ENERGY COMPLETE MONOGRAPH

**2021 PUBLIC INPUT TO THE 2021 IECC, IRC CH. 11 AND
ICCPC CH.15**

Publication Date: December 2021

**FIGURE C301.1
CLIMATE ZONES**

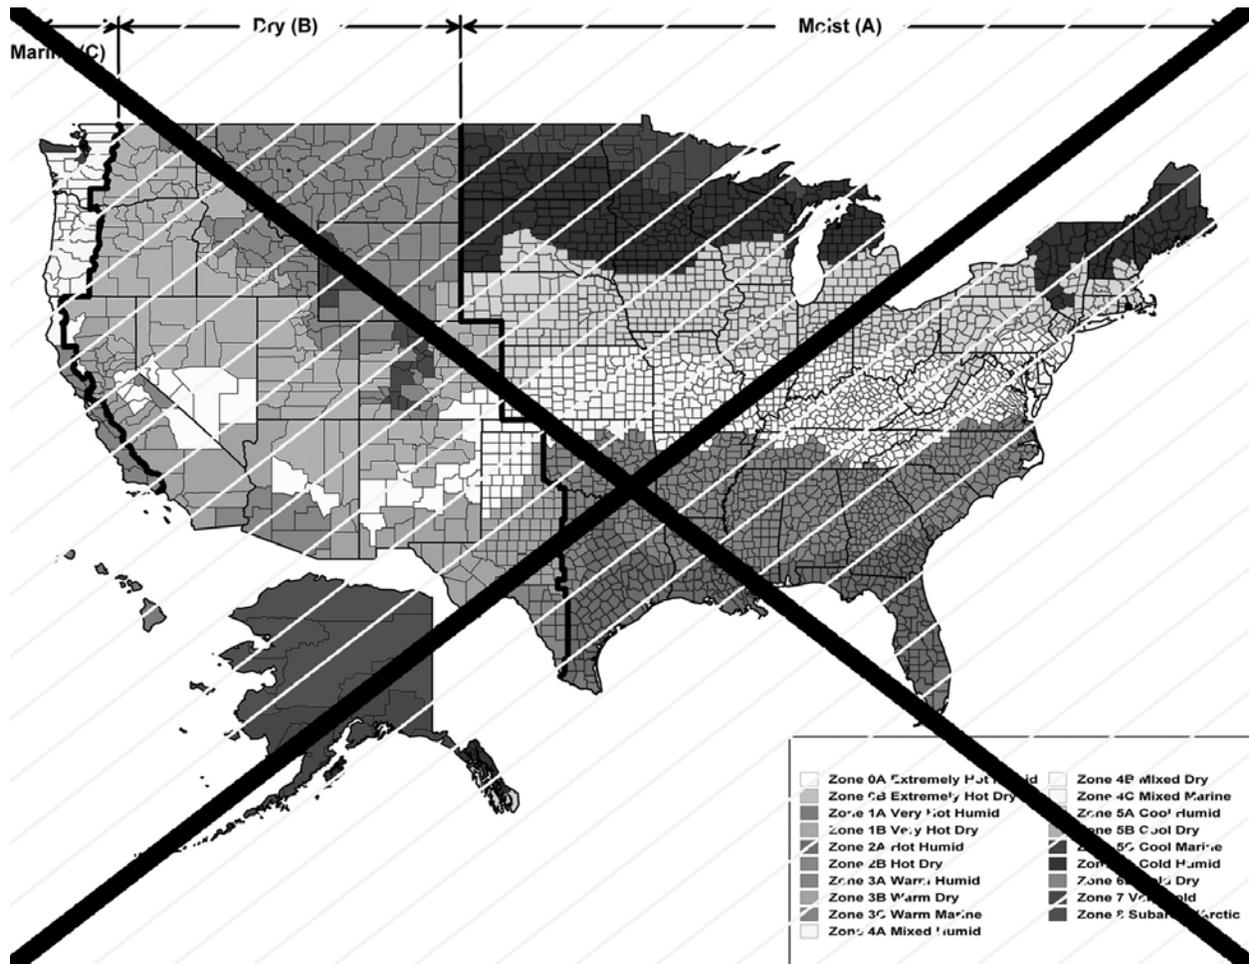
C301.1 General. *Climate zones shall be as specified in R301.* ~~from Figure C301.1 or Table C301.1 shall be used for determining the applicable requirements from Chapter 4. Locations not indicated in Table C301.1 shall be assigned a *climate zone* in accordance with Section C301.3.~~

Delete without substitution:

FIGURE C405.2.4.2(2)
DAYLIGHT ZONE UNDER A ROOFTOP MONITOR

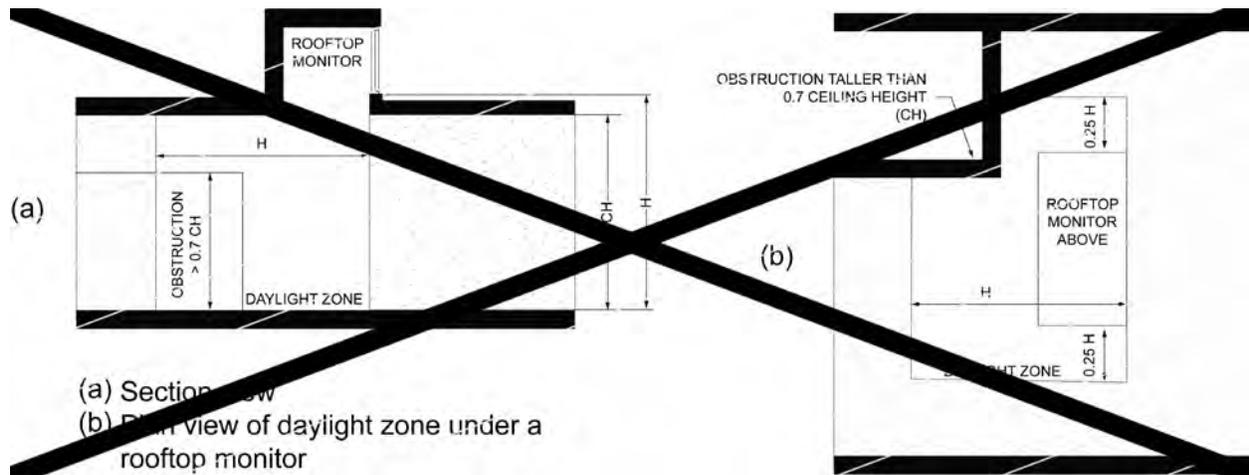
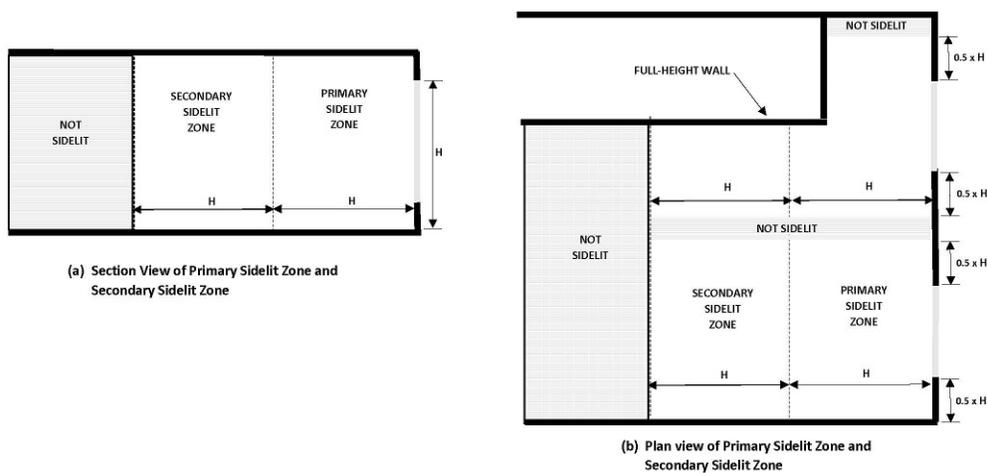
Delete and substitute as follows:

(a) Section View of Primary Sidelit Zone and Secondary Sidelit Zone

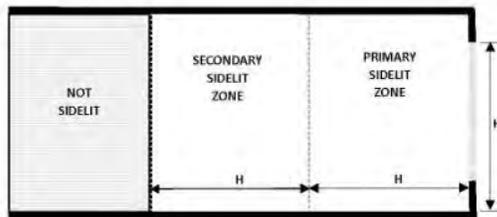
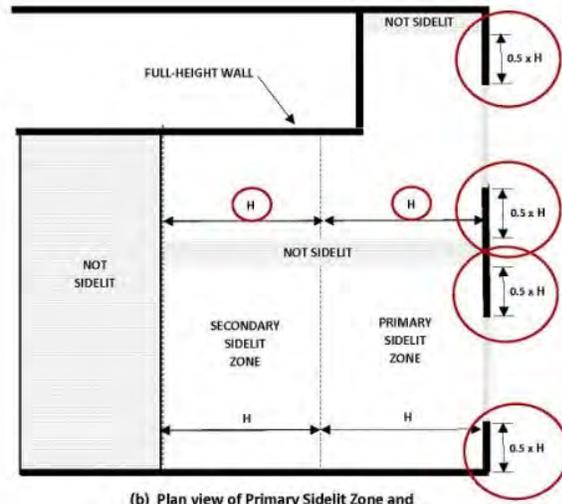
Reason: Figure C405.2.4.2(1) is incorrect. The definition for a sidelit daylight zone is to extend longitudinally from the edge of the fenestration up to 0.5 times the height from the floor to the top of the fenestration. Figures attached show in red outline where the figure needs correction in order to match the definition of a sidelit daylight zone in C405.2.4.2.

1. Where the fenestration is located in a wall, the primary sidelit daylight zone shall extend laterally to the nearest full-height wall, or up to 1.0 times the height from the floor to the top of the fenestration, and longitudinally from the edge of the fenestration to the nearest full-height wall, or up to 0.5 times the height from the floor to the top of the fenestration, whichever is less, as indicated in Figure C405.2.4.2(1).

3. Where the fenestration is located in a wall, the secondary sidelit daylight zone is directly adjacent to the primary sidelit daylight zone and shall extend laterally to 2.0 times the height from the floor to the top of the fenestration or to the nearest full height wall, whichever is less, and longitudinally from the edge of the fenestration to the nearest full height wall, or up to 0.5 times the height from the floor to the top of the fenestration, whichever is less, as indicated in Figure C405.2.4.2(1). The area of secondary sidelit zones shall not be considered in the calculation of the daylight zones in Section C402.4.1.1.
